Chapter 5. General Site and Building Elements

Figure 502.9.1 – Wide sidewalk

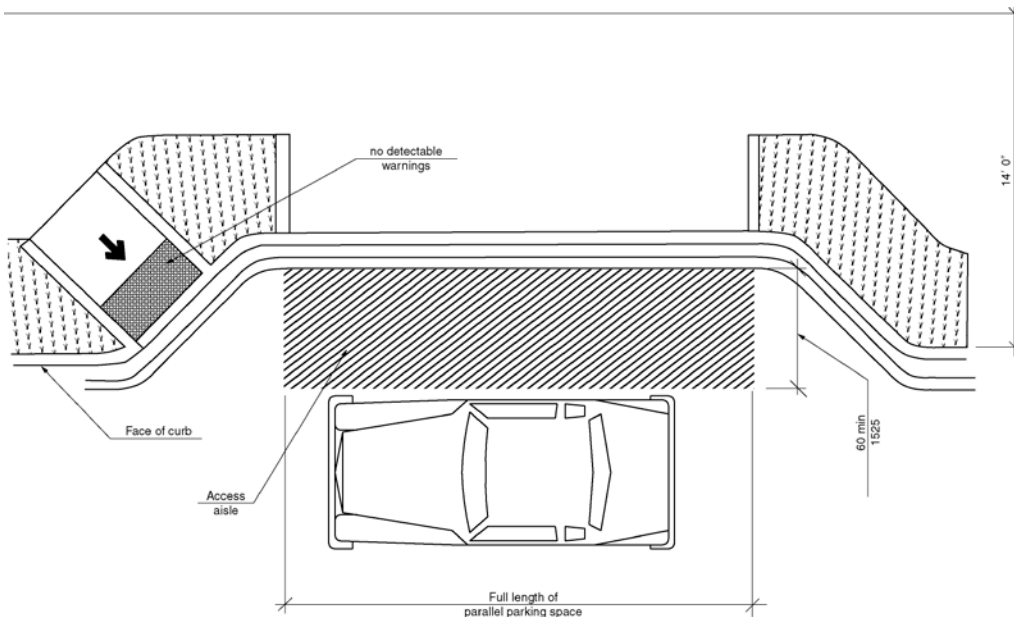
Comment [KP2]: Greater than 14'

Figure 502.9.1.2 - Narrow sidewalks

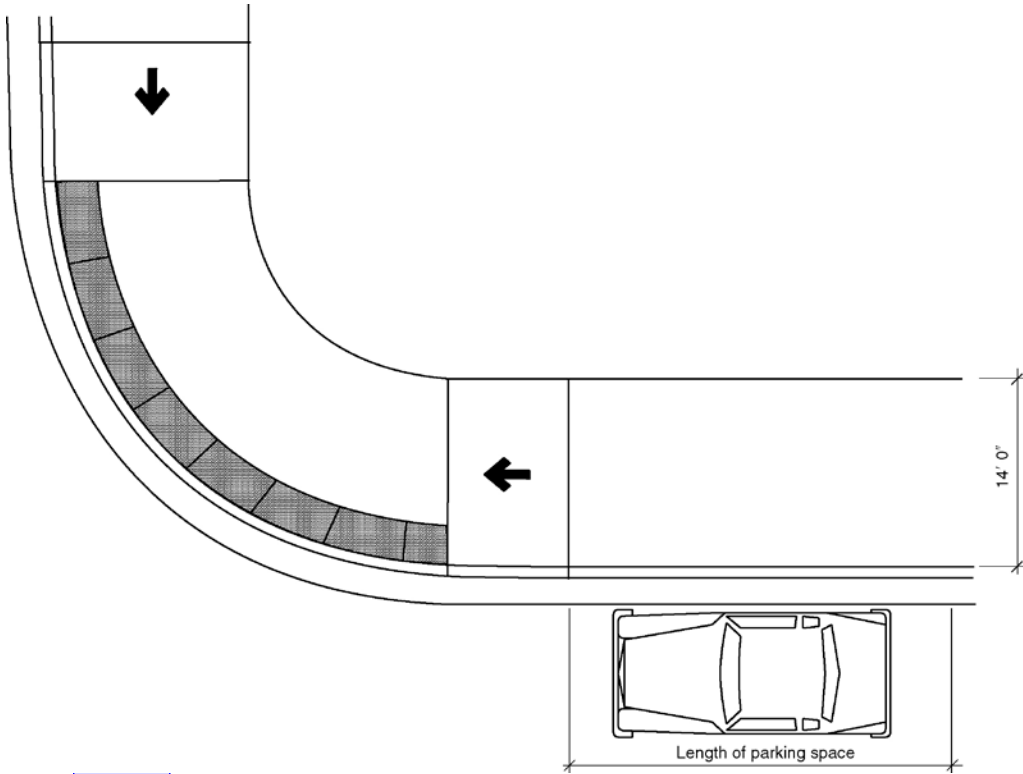
Comment [KP3]: Sidewalk $\leq 14'-0''$

Figure 504.5 (a) thru (d) - Treads and risers for stairways

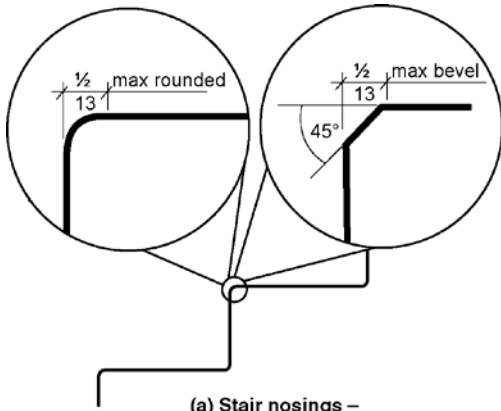
(Note: Additional verbiage - Suggest adding the same language in #3 as in Item #2 for the leading edge, otherwise can be read as conflict with the 1-1/2 nosing bevel on the underside of the tread. This will be further clarified in the figures.)
